**BEFORE THE PUBLIC UTILITIES COMMISSION  
OF THE STATE OF CALIFORNIA**

Rulemaking 18-10-007  
(Filed October 25, 2018)

**COMMENTS OF THE UTILITY REFORM NETWORK  
ON WILDFIRE MITIGATION PLANS**

**Figure 1: Frequency of Ignition Incidents (2014-2017) per Mile of Distribution Overhead Conductor In High Fire Districts Is Similar for PG&E and SDG&E**

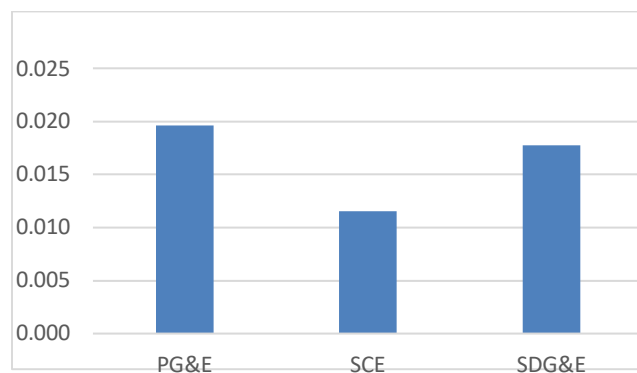
The Risk discussions<sup>36</sup> in the large utilities' WMPs do not focus sufficiently on the specific risk that WMPs are supposed to address – the risk of catastrophic wildfires.<sup>37</sup> Instead of defining the risk event in this way, they define it more broadly, as the risk of utility-caused CPUC reportable ignitions in high fire threat areas (PG&E and SCE) or even broader yet, as just utility-caused wildfires without narrowing the geographic location (SDG&E).<sup>38</sup> There is significant evidence that reportable ignitions are not the right focus. As TURN noted at the February 13<sup>th</sup> workshop, from 2015-2017, PG&E and SDG&E had almost the same number of CPUC reportable ignitions per mile on distribution facilities in high fire threat districts, as shown in the figure below.

SDG&E is held up as an example of a company that is effectively managing the wildfire risk, but the main difference in the experience of PG&E and SDG&E in recent years is that SDG&E has not had a catastrophic wildfire, while PG&E's facilities have caused many catastrophic wildfires.
